Planning reference: 3/2025/0147

Location: Peel Street Business Estate, Peel Street, Clitheroe, BB7 1RA

Proposal: Proposed demolition of existing buildings and erection of six 2-bed and one 3- bed apartment building together with a two storey business centre and associated parking and bin store

CLEARANCE DISTANCES FROM MEARLEY BROOK

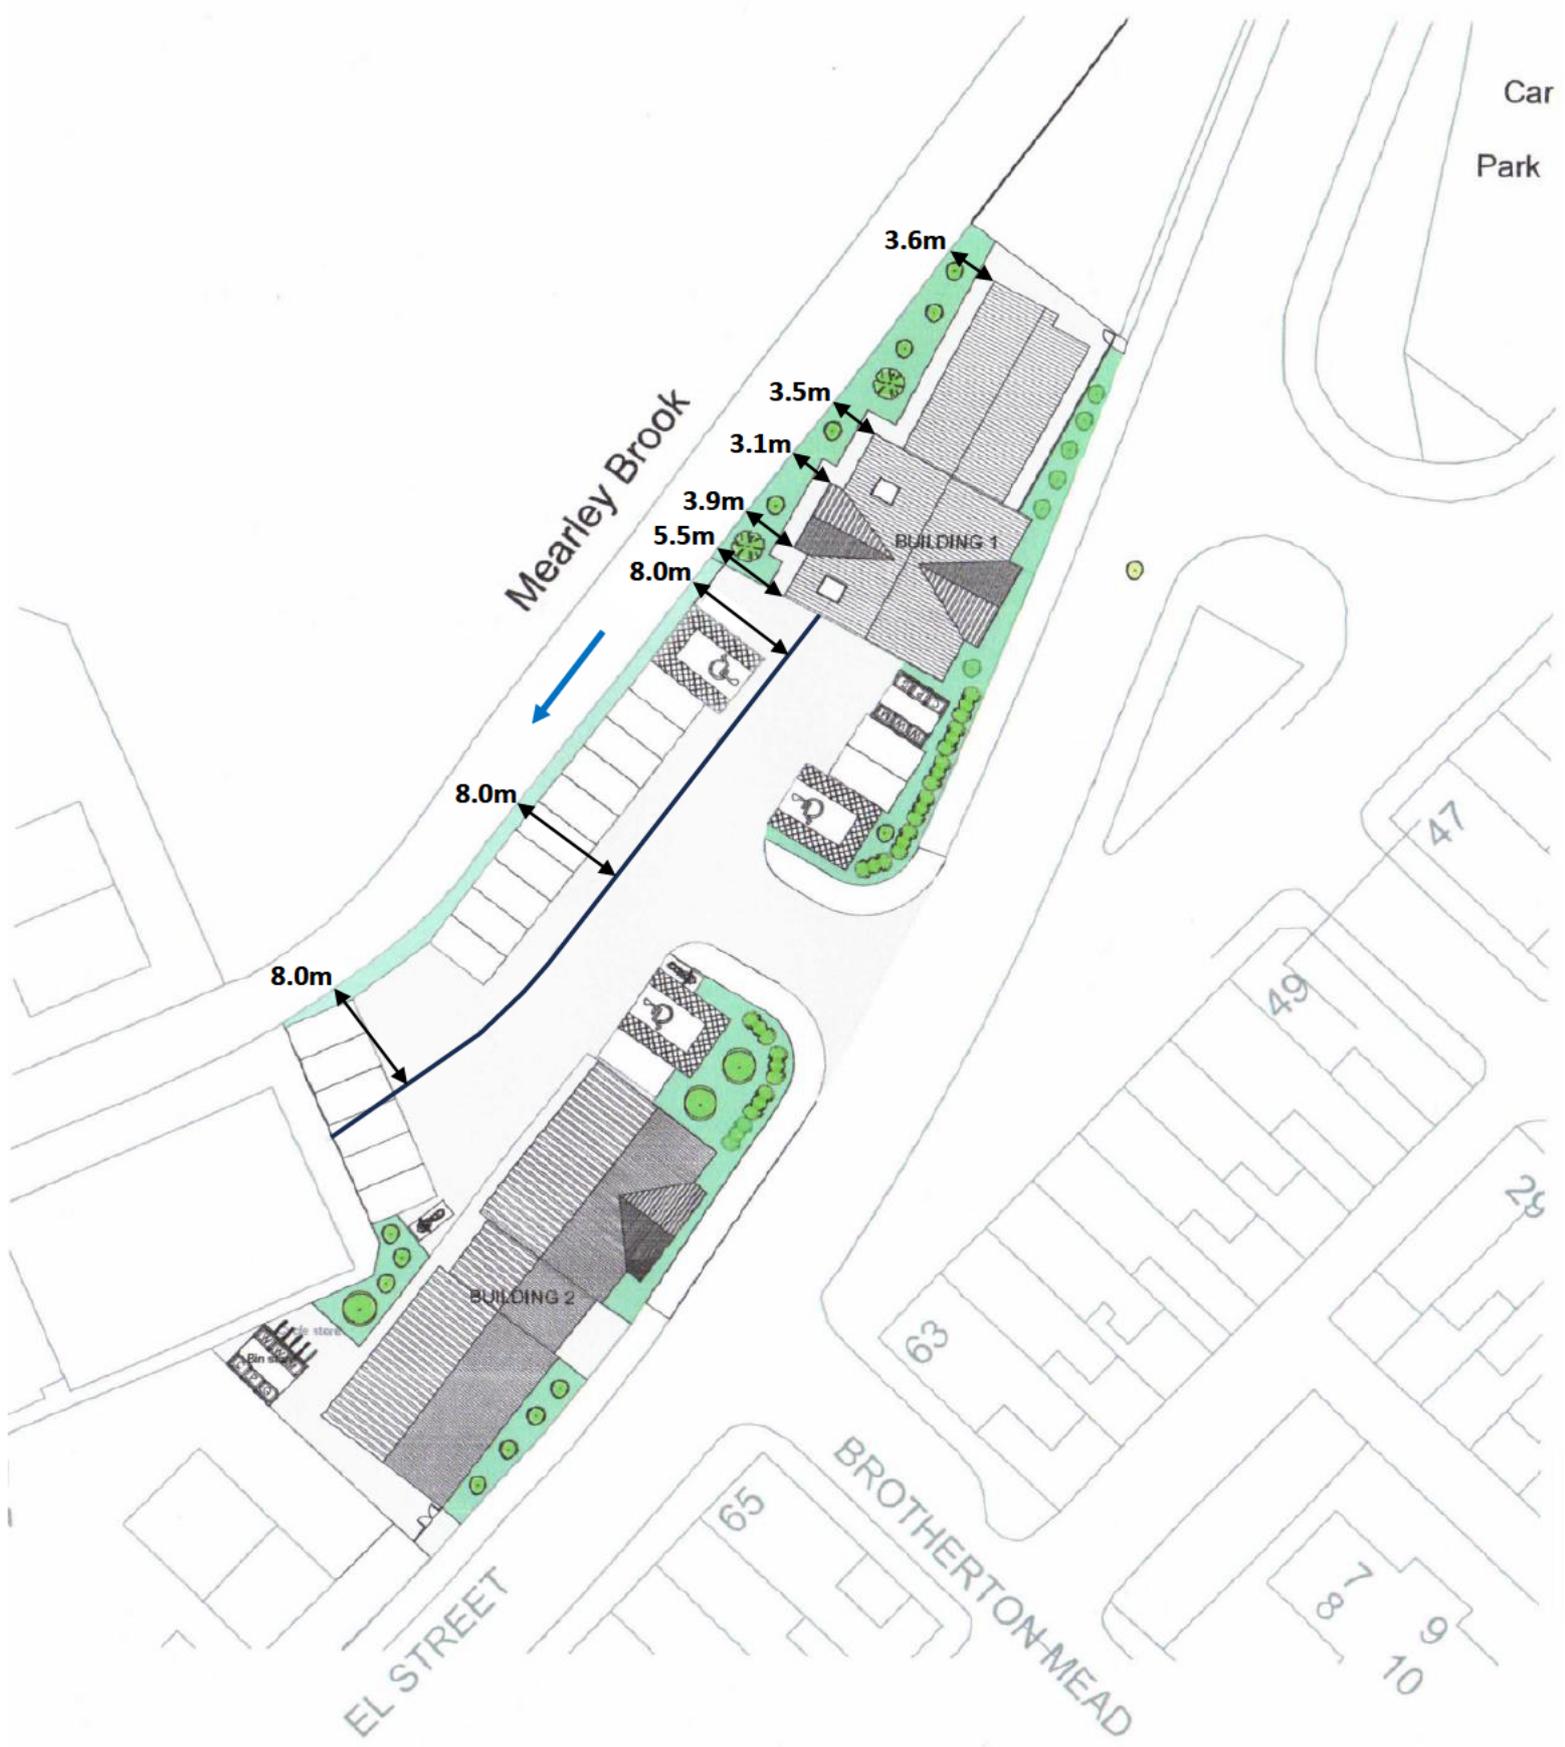
Plan and sectional drawings which clearly state the distance from the top of the riverbank to the development at its closest point, based on topographical survey data, including any boundary fencing or walls. They should demonstrate that a minimum of 8 metres is left unobstructed and that Environment Agency access to and along that watercourse is not impeded.

We are unable to provide sections that demonstrate a minimum 8 metres is left unobstructed between the top of the river bank and the development at its closest point.

Examining the existing site layout prior to any development, the two separate buildings within the existing site, one of which lies within the centre of the site, are within 8m to the top of the river bank over a distance of 6.5m and 10.5m.

On the proposed site layout, only the single proposed building in the extreme northern part of the site will be within 8m of the top of the river bank along its total length 25.2m but no closer than 3.1m, a similar distance to the buildings on the adjacent site immediately downstream. The remainder of the site is to be used as car parking and can provide clear unobstructed access for maintenance. The proposed site plan is attached with clearance distances marked on.

CAR WASH CENTER, VAN HILL + SLOTT'S ROAD, PACE ST, CANTONVILLE

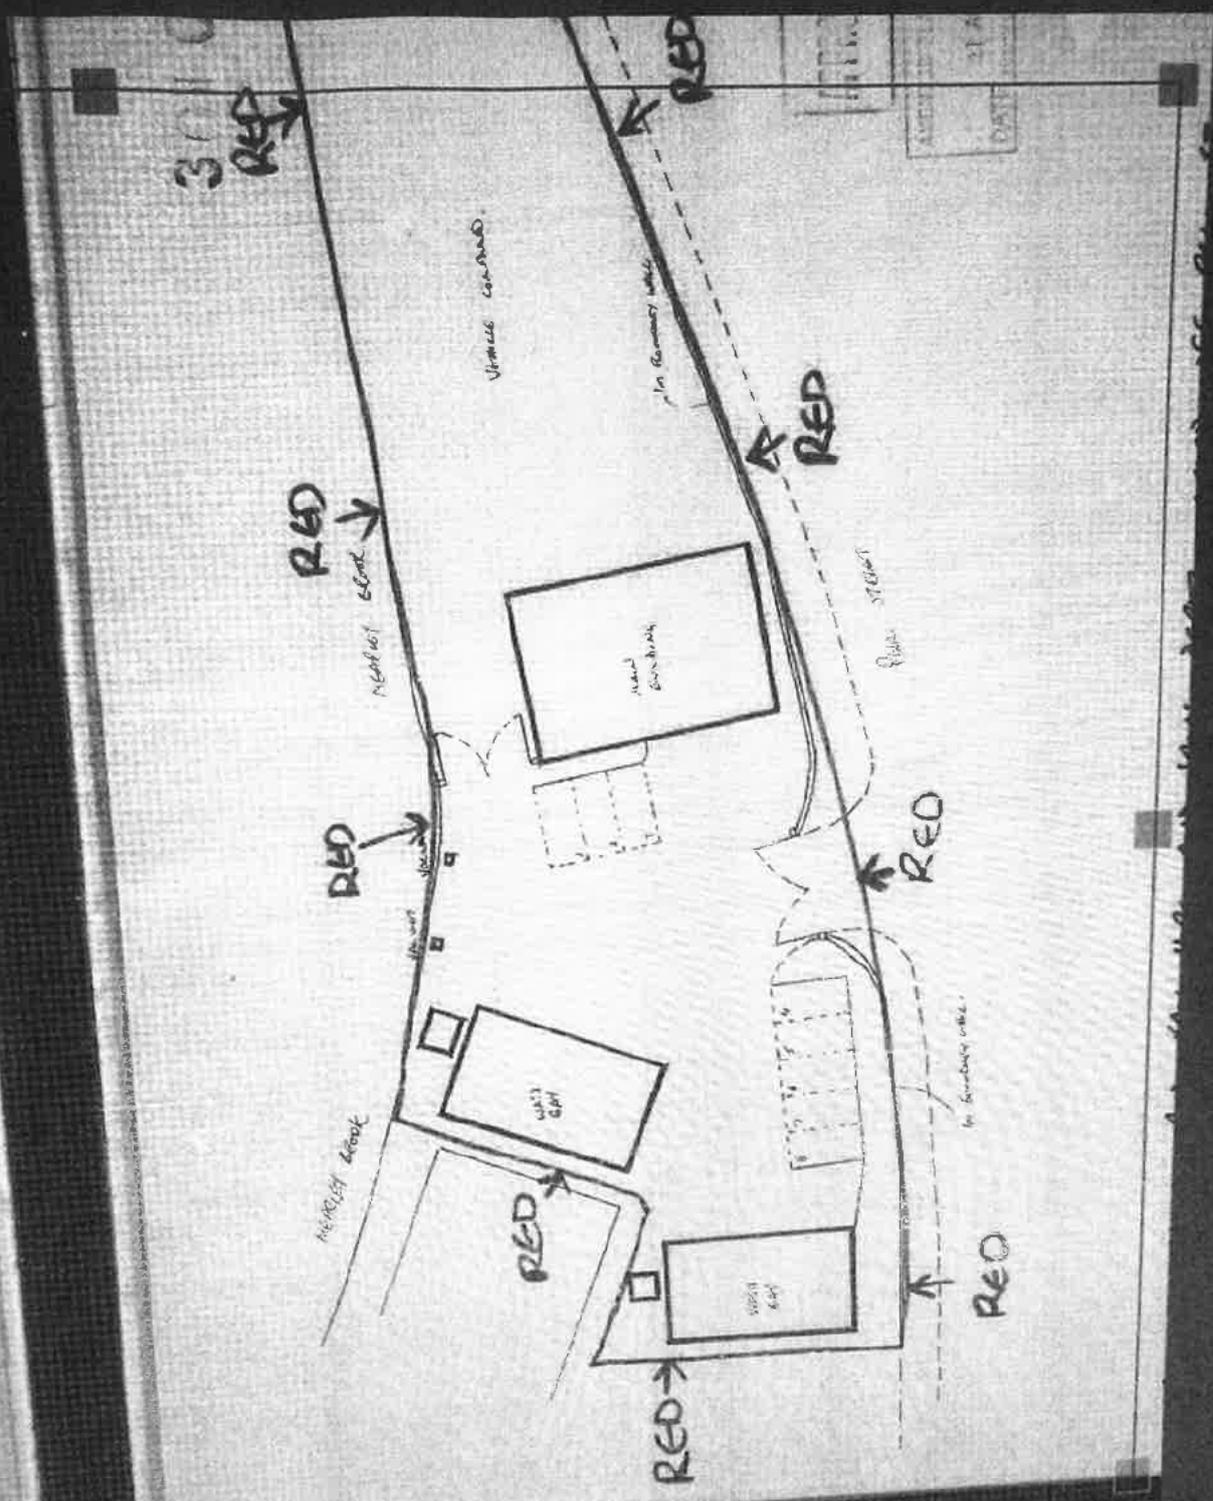
The proposed development is unacceptable because of its proximity to the top of the bank of the watercourse: Mearley Brook. The permanent retention of a continuous unobstructed area is an essential requirement for future maintenance or improvement.

The watercourse adjoining the site is designated a "main river" and is therefore subject to Land Drainage Byelaws. In particular, no trees or shrubs may be planted, nor fences, buildings, pipelines or any other structure erected within 8 metres of the top of any bank/retaining wall of the watercourse without prior Consent of the Agency.

To overcome our concerns, the Agency requests a revised site layout to show the required 8 metre access strip. Please send any plans to Cliff Welsby at Lutra House.

As the amended plans now show the development to be approximately 5m from the top of the bank bank of the main river, Mearley Brook, I can confirm that we can withdraw our objection. It should be noted, however, that the applicant has not yet applied for Land Drainage Consent from the Agency to include the reduction of the required 8m access strip to 5m.
